Access Audit Site Report

Ray Roberts Lake State Park/Complex

Accessibility Evaluation

Inspection Date: 10/18/2021

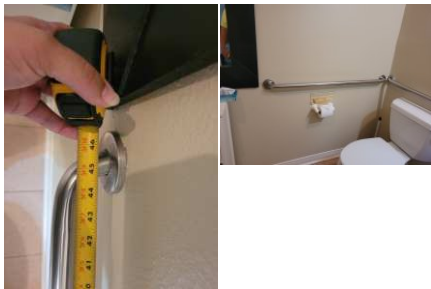
506	Jordan Park: Jordan - Lone Star Lodge Public Spaces	[33.40596, -96.99995]	Element meets all standards and requirements	Small meeting room complies	None	2010 ADAS Section: N/A		
507	Jordan Park: Jordan - Lone Star Lodge Public Spaces	[33.4058525 , -97.000172 9]	The operating hardware is not accessible because it requires tight grasping, pinching or twisting of the wrist to operate. Hand-activated hardware, handles, pulls, latches, locks, and other operating devices on accessible elements shall have a shape that is easy to grasp with one hand and does not require tight grasping, tight pinching or twisting of the wrist to operate.	Small meeting room-sliding door hardware fails	For all doors along the public circulation route, replace hardware with lever hardware where indicated.	2015 ABAAS Section: 309.4 2012 TAS Section: 309.4 2010 ADAS Section: 309.4		 Lever Panic Bar Looop Handle Operating hardware must be centered between 34" and 44" above the floor or ground

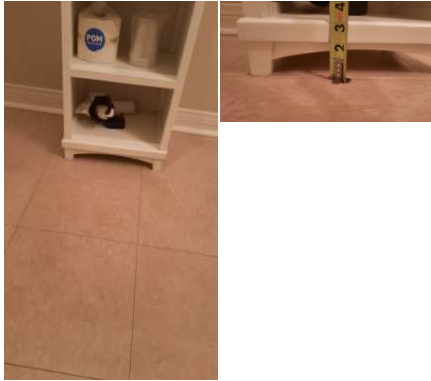
529	Jordan Park: Jordan - Lone Star Lodge Guest Rooms	[33.4061833 , -96.999725 2]	The shower seat does not have a compliant space between it and the wall. The folding seat must be mounted 17-19 inches above the floor, and have a maximum space of 1-1/2 inches between the edge of the seat and the side wall and 2-1/2 inches maximum to the seat wall.	Rm 114 - seat mounted with 2" gap at back wall	Remount shower seat to the correct location and height in the shower.	2015 ABAAS Section: 610.3.2 2012 TAS Section: 610.3.2 2010 ADAS Section: 610.3.2

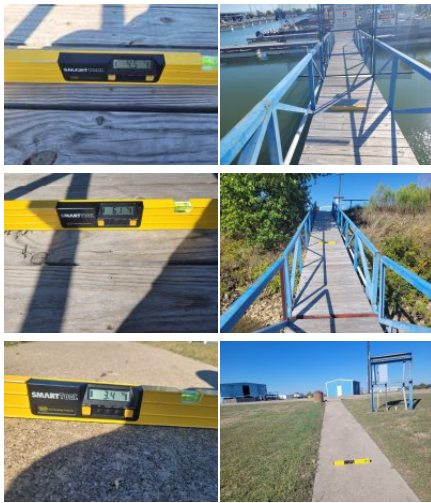
1117	Sanger Park: Sanger - Marina Boathouse 1	[33.3772272, -97.107094]	The minimum number of boat slips is not provided. Where the number of boat slips is not identified, each 40 feet of boat slip edge provided along the perimeter of the pier shall be counted as one boat slip.	0 of 76 boat slips accessible in this boathouse, 501 present at site requiring minimum of 8 accessible boat slips dispersed throughout the types and locations provided	Provide the required number of boat slips based on the total provided, or for every 40' of boat slip edge.	2015 ABAAS Section: F235.2 2010 ADAS Section: 235.2

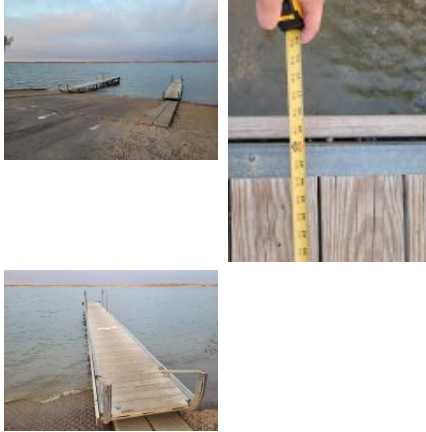
Finding Number	Area Description	Lat/Long	Finding	As Built	Recommendation	Citation	Photos	Figure
1309	Pond Boat Launch: Pond - Boat Ramp	[33.38705, -97.10703]	The minimum number of boarding piers are not accessible. Where boarding piers are provided at boat launch ramps, at least 5 percent, but no fewer than one, of the boarding piers be accessible.	2 piers with 8 or 6 tie offs, change in level (CIL) to access piers, one pier has CILs along pier, 50" wide	Provide 5%, but not less than one accessible boarding pier at boat launches.	2015 ABAAS Section: F235.3 2010 ADAS Section: 235.3
